UNITED STATES ENVIRONMENTAL PROTECTION AGENCY
ONE CONGRESS STREET, SUITE 1100
BOSTON, MA 02114-2023

March 8, 2007

Re: Conditional Approval of General Electric's December, 2006 submittal titled
*Supplemental Soil Evaluation Report and Removal Design/Removal Action Work Plan
Addendum for Selected Phase 2 Floodplain Properties Adjacent to the 1 ½ Mile Reach of
the Housatonic River, GE-Pittsfield/Housatonic River Site, Pittsfield, Massachusetts.*

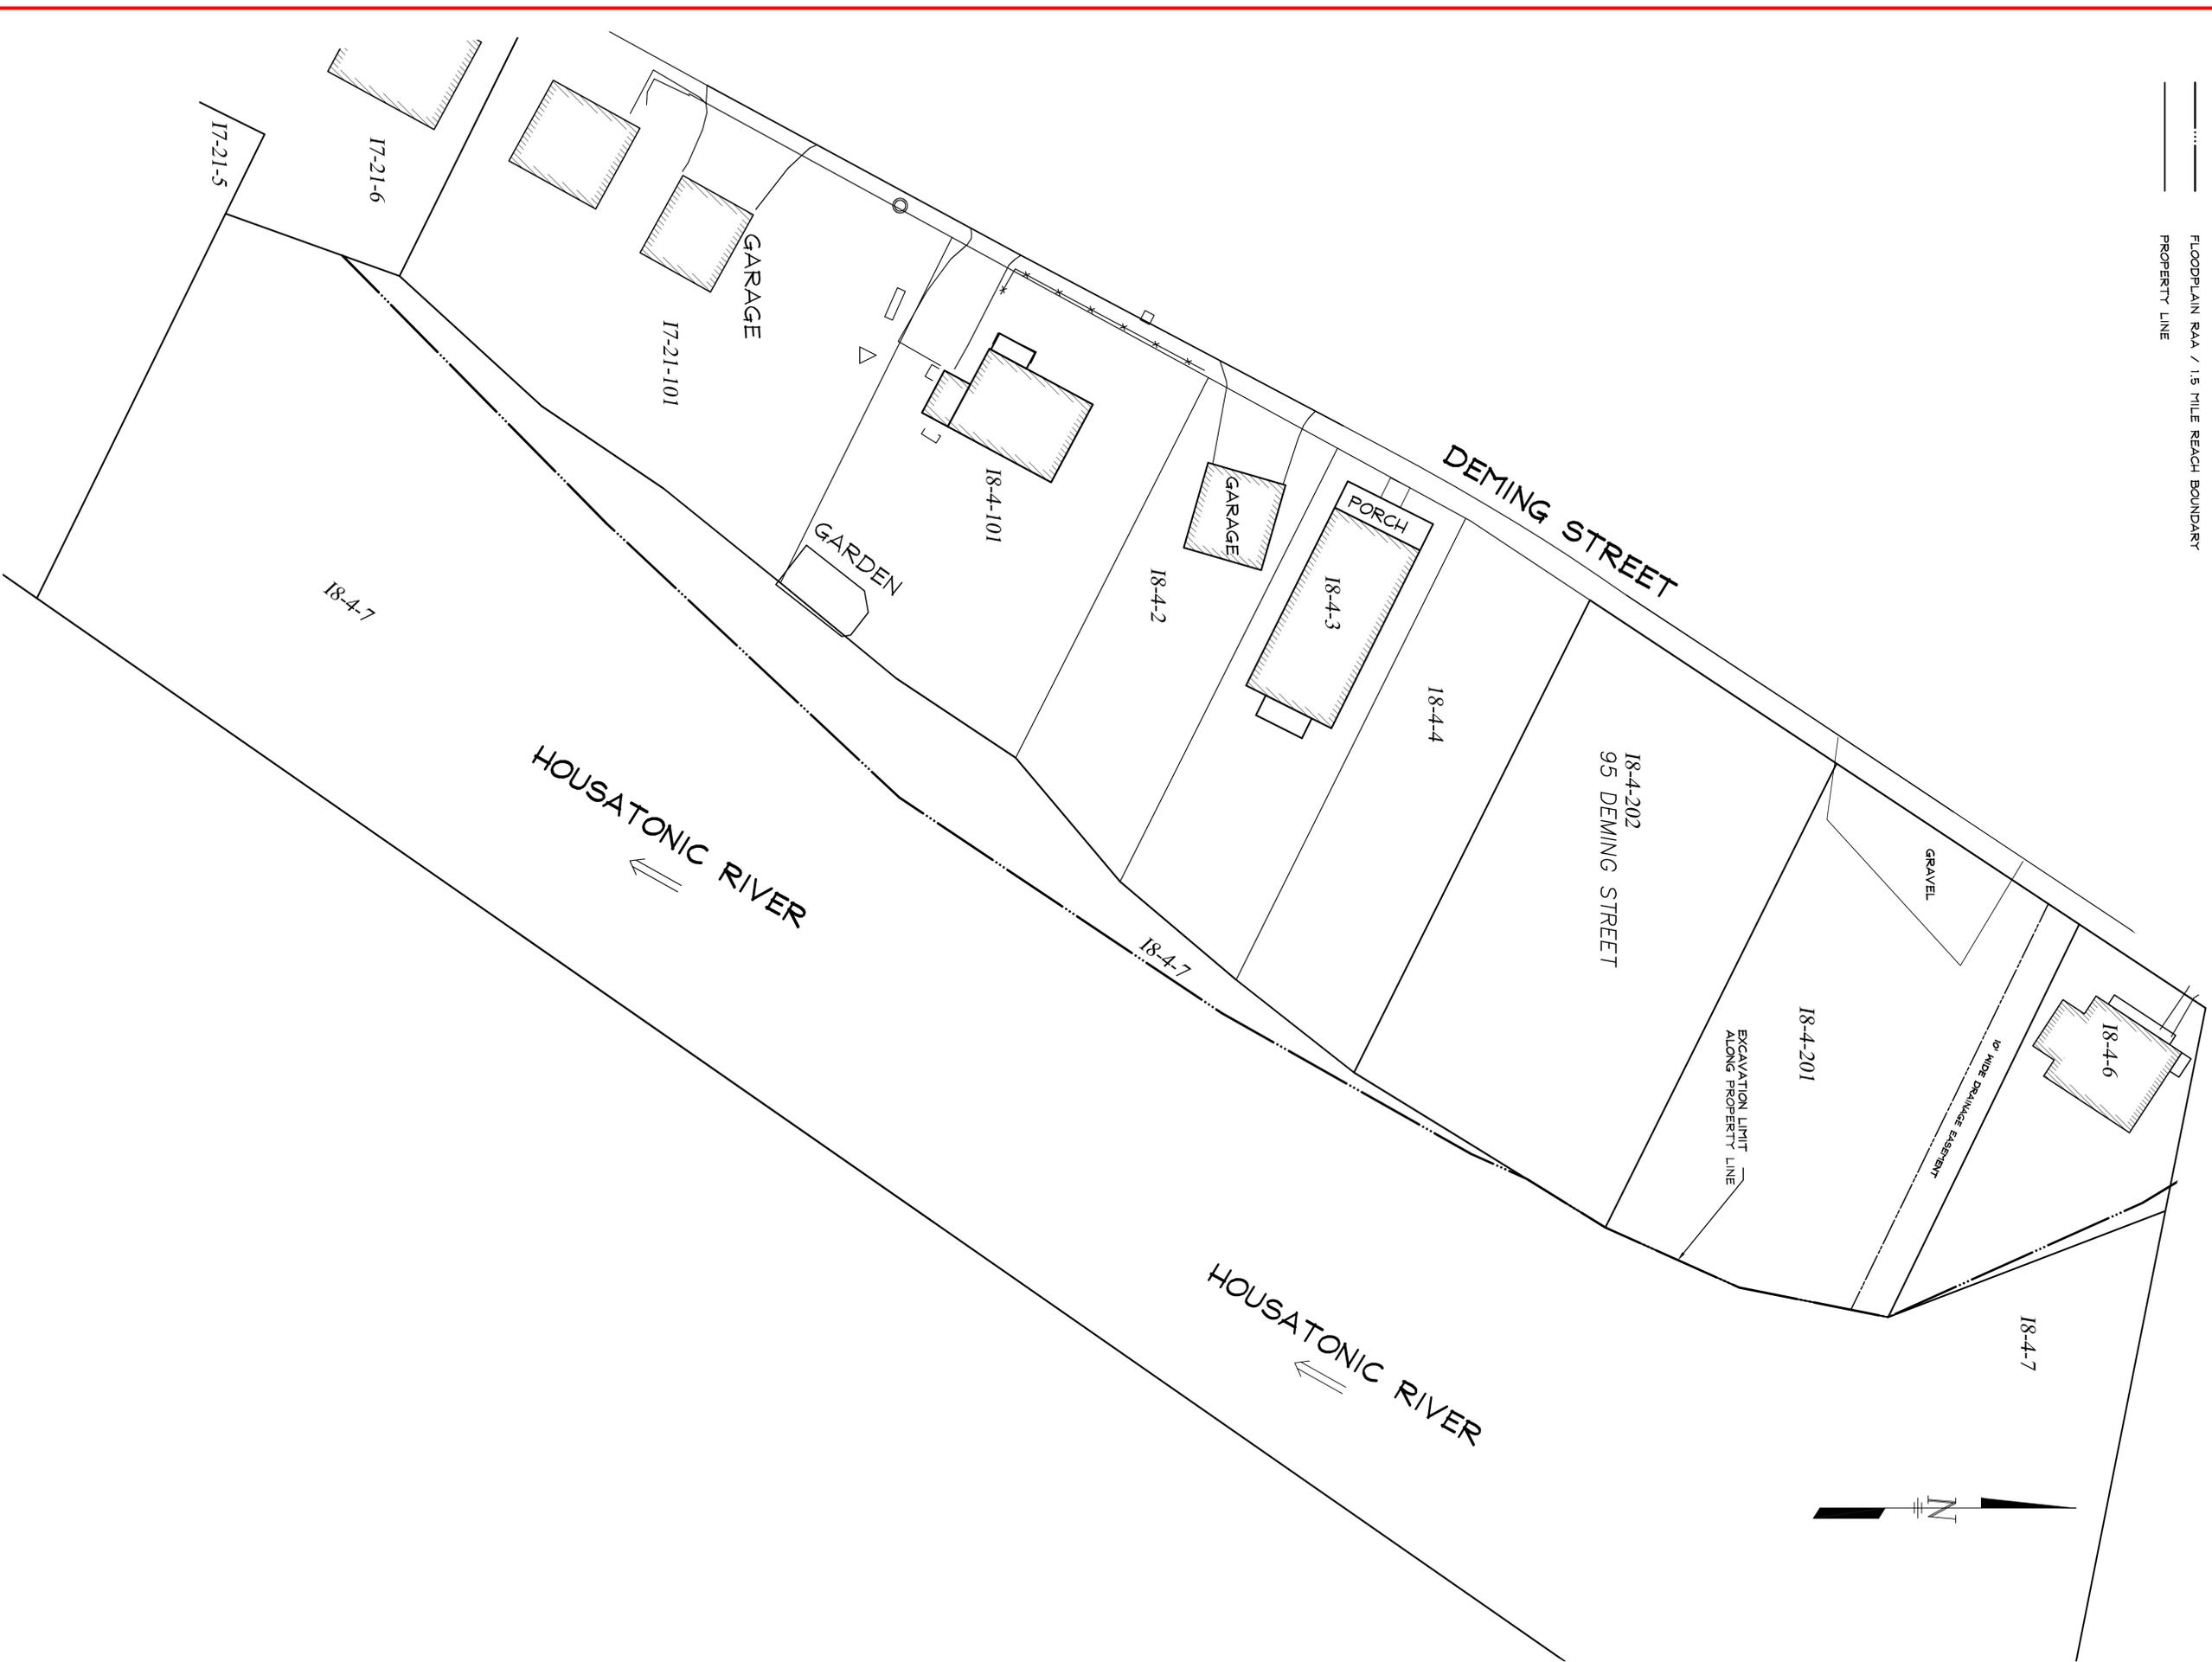
1. Based on an updated and more detailed topographic survey and other factors, EPA modified the boundary that was previously agreed upon by GE and EPA between the 1 ½ Mile Removal Action and GE's 1 ½ Mile Floodplain RAAs and that was utilized in GE's previous Removal Design/Removal Action (RD/RA) evaluations. The modified area is near the property lines for 18-4-6, 18-4-201, 18-4-202 and 18-4-7. The attached map dated 2-12-07 (revision D) and titled Floodplain RAA/1.5 Mile Reach Boundary depicts the revised boundary. GE shall revise the previous RD/RA evaluations for Parcels I8-4-6 and I8-4-201/202 using the boundary shown on the attached map.
